3000-3500 MARINA BOULEVARD (BRISBANE, CALIFORNIA) SITE PLAN REVIEW

Memorandum

Subject: 3000-3500 Marina Boulevard (Brisbane, California) Site Plan Review

CITY OF BRISBANE
3000-3500 MARINA BOULEVARD
SITE PLAN PARKING GARAGE GROUND FLOOR
RECOMMENDATIONS

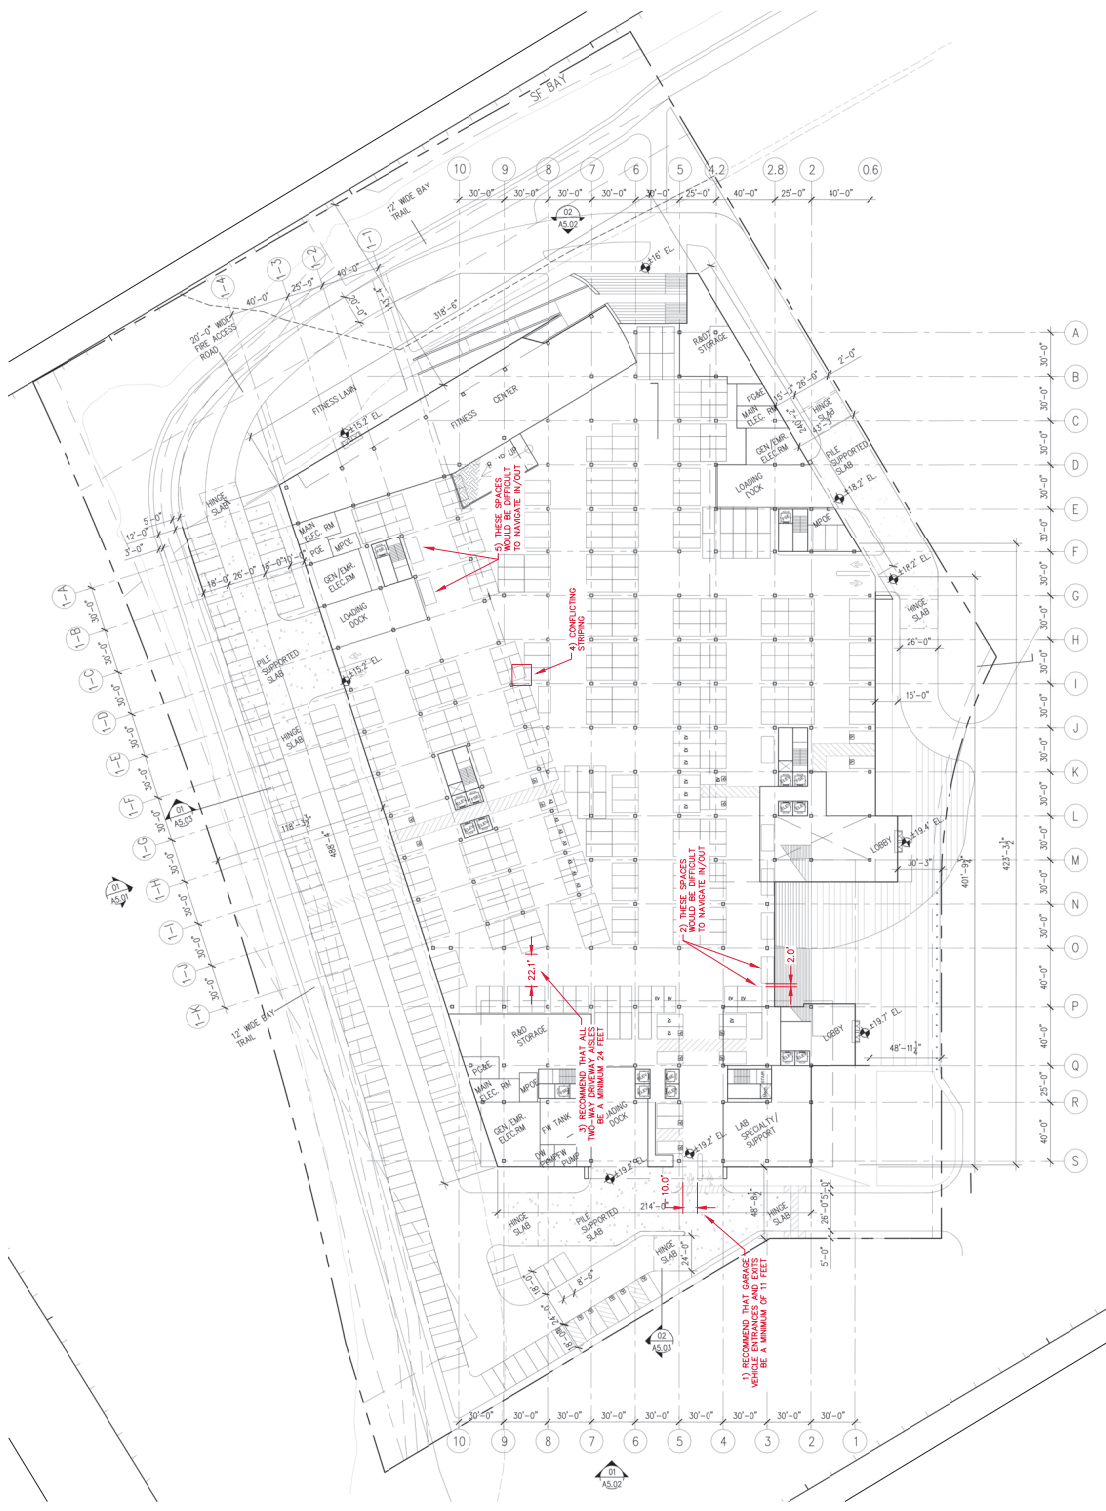
1. The vehicle exit on the south end of the parking garage is shown to be 10 feet wide. It is recommended that all garage vehicle entrances and exits be a minimum of 11 feet wide.

2. The vehicle parking spaces in the southeast corner of the garage, near plan grid lines O-P and 3-4, would be difficult to navigate into and out of. As shown, there is only 2 feet of clearance between the stalls, thus, these stalls would not be useable at the same time.

3. The east-west drive aisle between plan grid lines O-P and 8-9 is shown to be approximately 22 feet. It is recommended that all two-way drive aisles be a minimum of 24 feet.

4. There is overlapping striping shown between two vehicle parking stalls near plan grid lines H-I and 8-9. As shown, the lines for the two stalls are conflicting.

5. The two parking spaces near plan grid line 1-2 between 1-B and 1-D would be difficult to maneuver into due to the circulation of the garage. Drivers would need to make a U-turn to enter into these spaces.

CITY OF BRISBANE
3000-3500 MARINA BOULEVARD
SITE PLAN PARKING GARAGE LEVEL 2
RECOMMENDATIONS

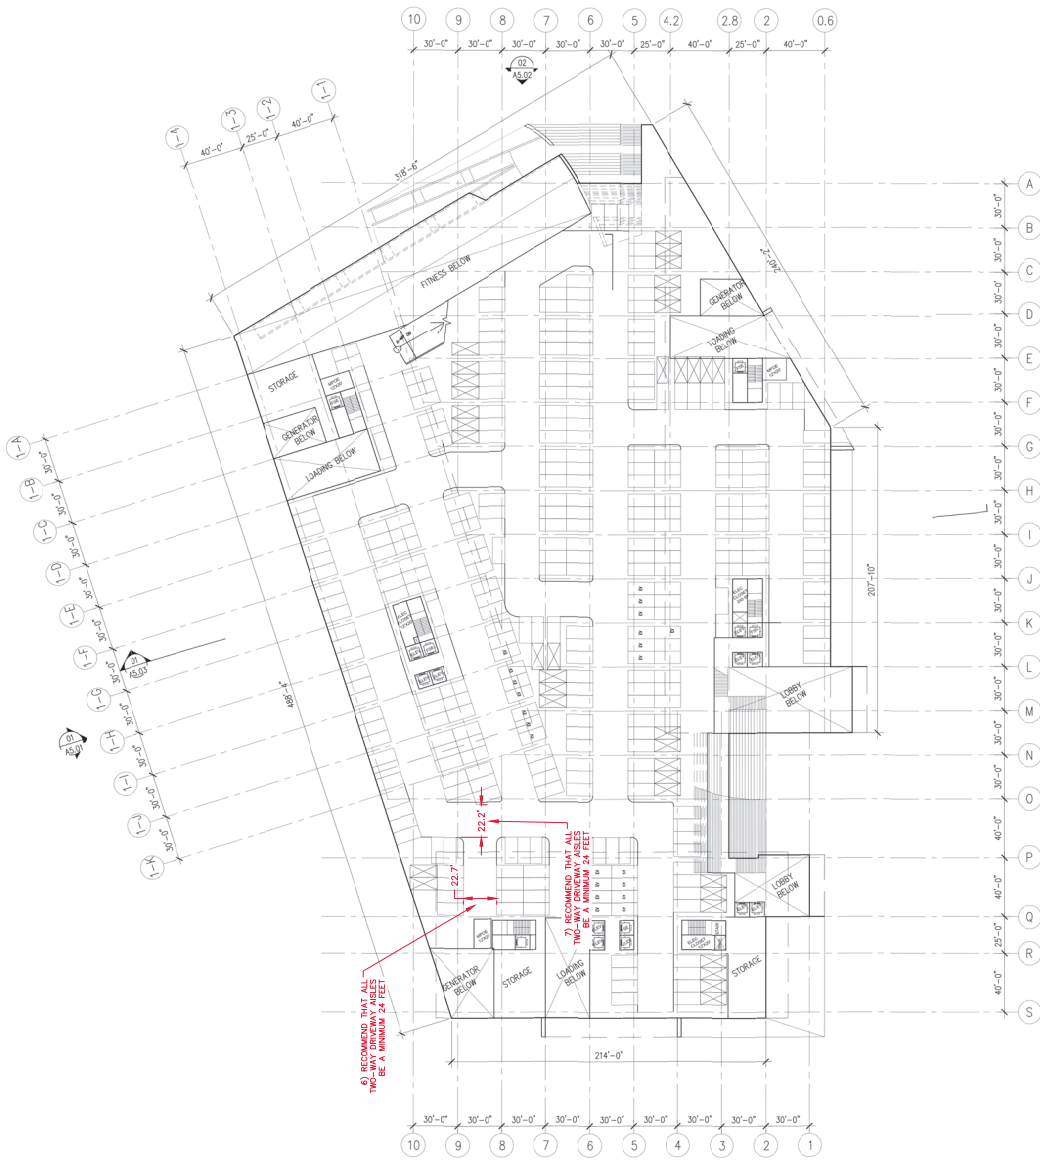
6. The north-south drive aisle between plan grid lines P-Q and 8-9 is shown to be approximately 23 feet. It is recommended that all two-way drive aisles be a minimum of 24 feet.
7. The east-west drive aisle between plan grid lines O-P and 8-9 is shown to be approximately 22 feet. It is recommended that all two-way drive aisles be a minimum of 24 feet.
